MODIFICATION REQUEST:

***Concept Plan for the Riverwood North
Estate Residential Renewal Project
Kentucky Road and Washington Avenue,
Riverwood
(MP 10_0167 MOD 3)***

***Increase to height of building envelopes, total
dwelling numbers and total gross floor area for
Phase 02 (Stage 2 and 3)***

Secretary's Environmental Assessment Report
Section 75W of the *Environmental Planning and
Assessment Act 1979*

Figure 6: Proposed envelopes for Phase 02 (Stage 2 and 3)

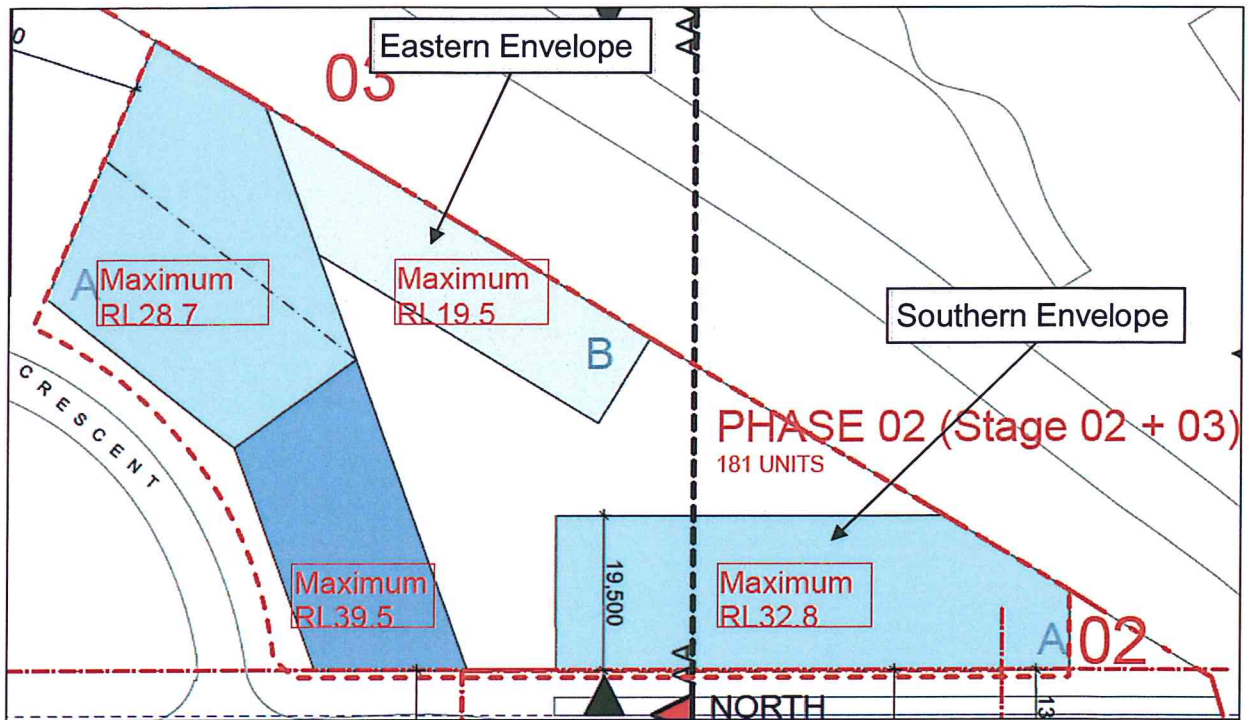
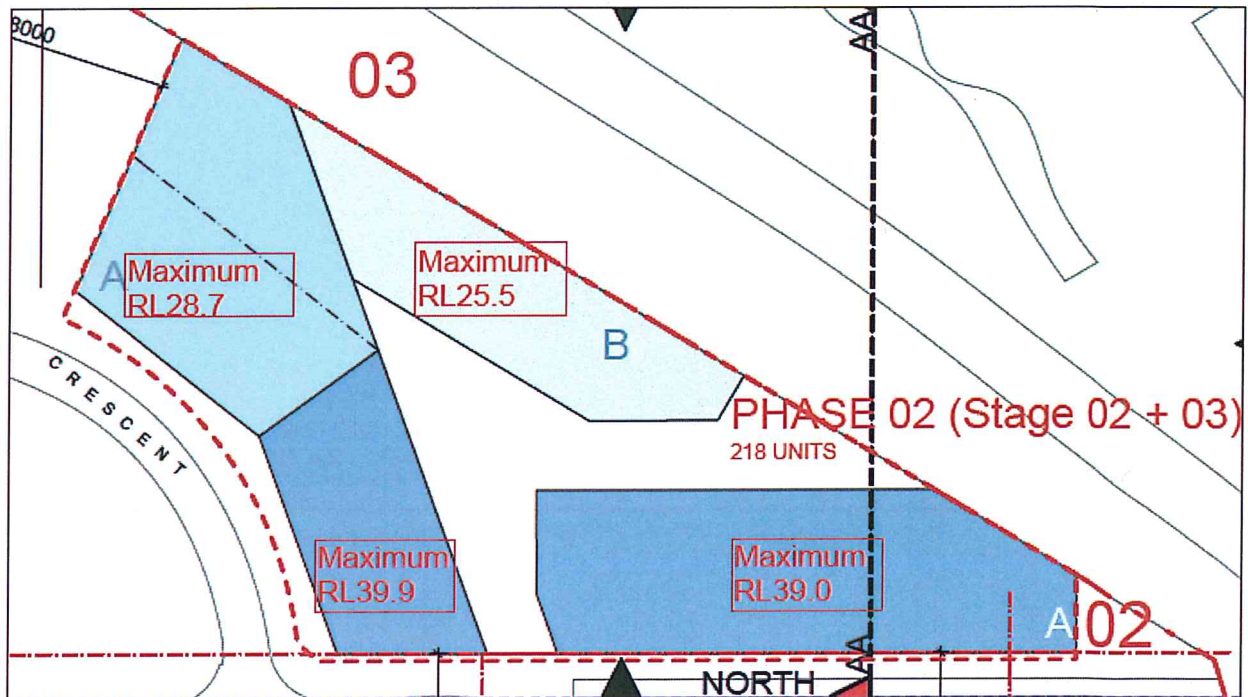
The proponent seeks to modify the building envelopes by increasing the building envelope height of the Eastern Envelope and Southern Envelope by up to two storeys (approximately 6.0 m) (see **Figure 6**), increasing the permissible floorspace from 15,901 sqm (FSR 3.0:1) to 19,690 sqm (FSR 3.77:1), and making minor amendments to the envelope footprint to better

The proposed minor amendments to the building footprints of the Eastern and Southern Envelopes result in decreases to the building separation distances, as follows:

- 11.5 m to 8.475 m between the Eastern Envelope B and Southern Envelope A; and
- 12.0 m to 9.1 m between the Eastern Envelope A and Southern Envelope A.

The Department is satisfied that the increased height of the building envelopes would have acceptable built form impacts as:

- the bulk and scale of the building envelopes are consistent with the surrounding built form and higher density urban character already established for the area;

- the height of the proposed building envelopes would be equal to or lower than the taller nine storey envelopes and 10 storey envelope within the concept plan site;

- the highest building envelopes are positioned on the southern portion of each block, which optimises amenity for future residents;
- the northern envelope continues to be significantly lower than the remainder of the concept plan to provide a transition to Salt Pan Creek Reserve; and

Figure 7: Approved mixed use development partly located on Phase 01 Building C site (see Figure 3)

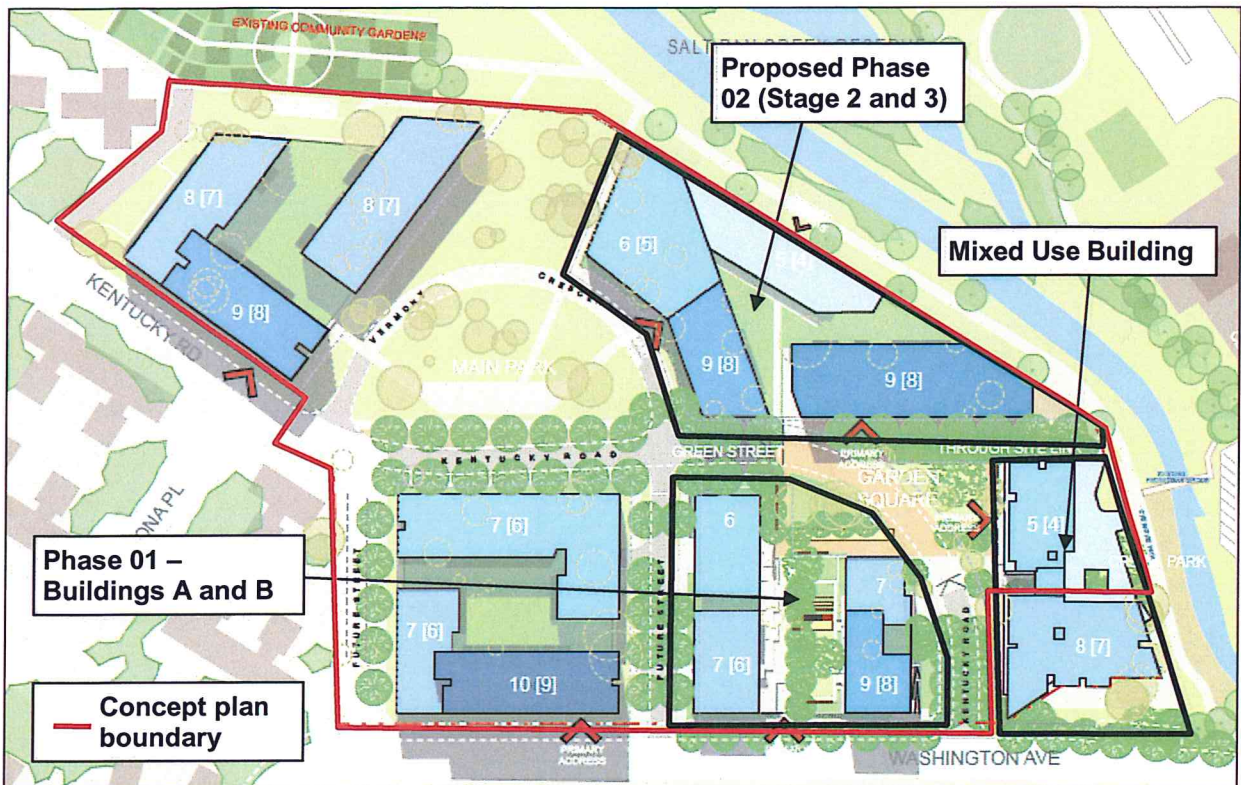
- the proposed increase of the Phase 02 (Stage 2 and 3) south-eastern building envelope from seven to nine storeys is comparable with the increased scale of the eight storey mixed use development to the south of the concept plan, approved by the Sydney East Joint Regional Planning Panel (see **Figure 7**).

Figure 8: Overshadowing from the proposed Phase 02 (Stage 2 and 3) envelopes during mid-winter at 9 am

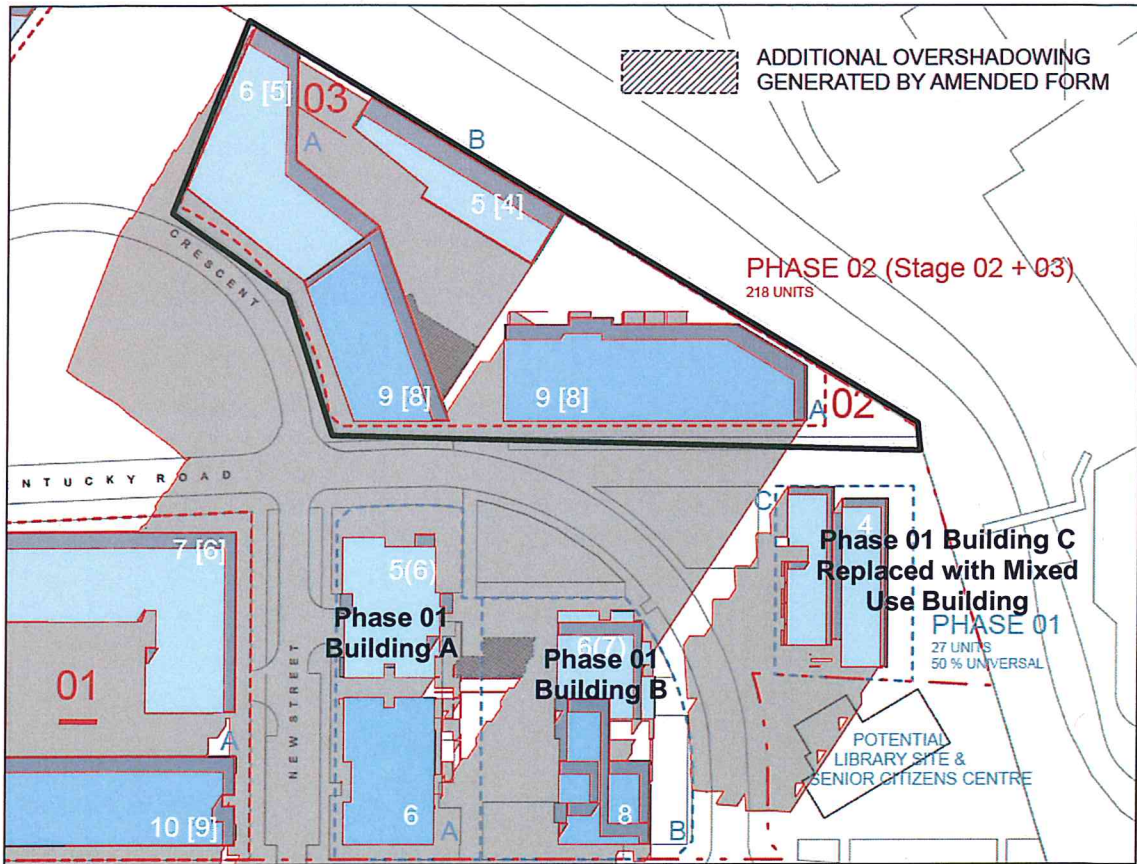
The two storey increase in height of the southern building envelope would create additional overshadowing on the completed social housing units in Phase 01 (Stage 1) and the mixed use building. In addition, the increased height of the northern component of the eastern envelope would overshadow units within the same building envelope to the south (see Figures 8 to 10).

The overshadowing from the additional two storeys on the southern envelopes would reduce solar access to the north eastern units within Phase 01 Building A and B. The proponent has advised that whilst the north-eastern apartments within Building A on the ground floor and upper ground floor and north facing units on the lower levels of Building B would encounter additional overshadowing they would still retain two hours of solar access in mid-winter in high density areas. The modifications would also result in three units of the mixed use development losing the minimum two hours of solar access required during mid-winter, however, the proponent has indicated that the overall number of dwellings receiving a minimum two hours of solar access during mid-winter would meet the 70 per cent recommended in the RFDC.

Figure 9: Overshadowing from the proposed Phase 02 (Stage 2 and 3) envelopes during mid-winter at midday

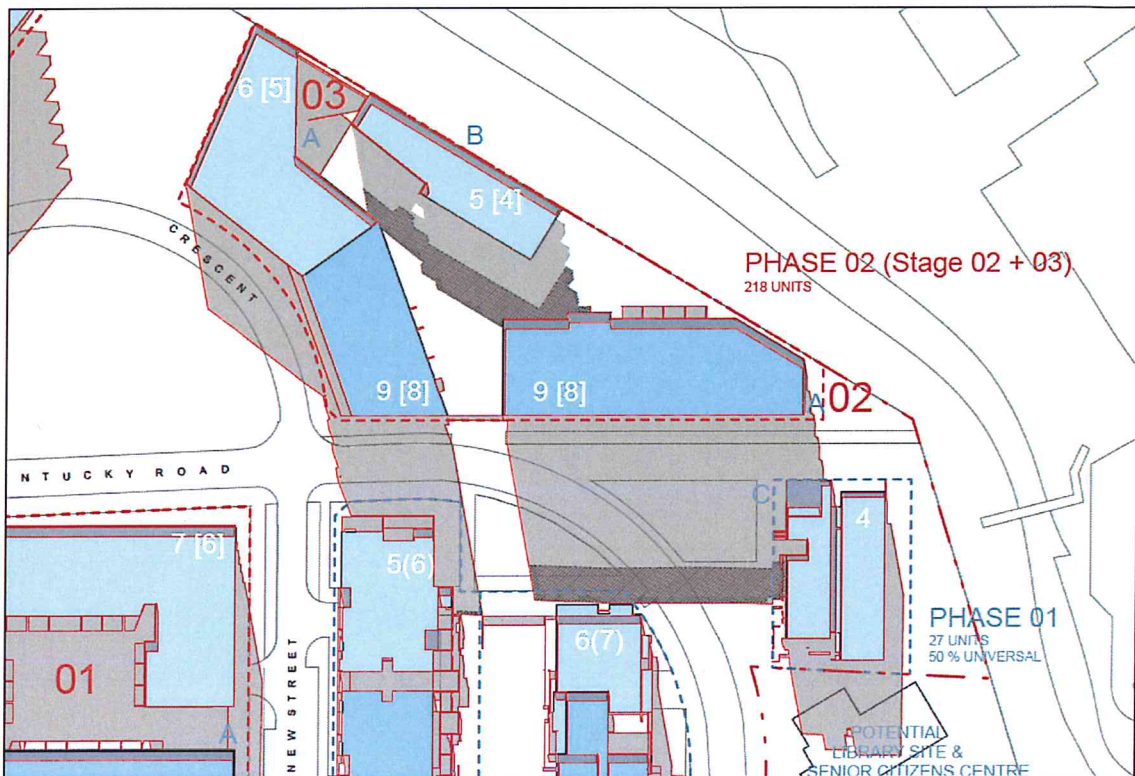
The increase in height of the southern envelope would also further overshadow Garden Square at 12 noon during mid-winter, resulting in an approximate 25 per cent increase in overshadowing. Notwithstanding, the current design already results in substantial overshadowing of this open space area (see **Figure 9**), with the additional overshadowing predominantly limited to hard landscaped/pedestrian access areas and generally no additional overshadowing projected to soft landscaped areas.
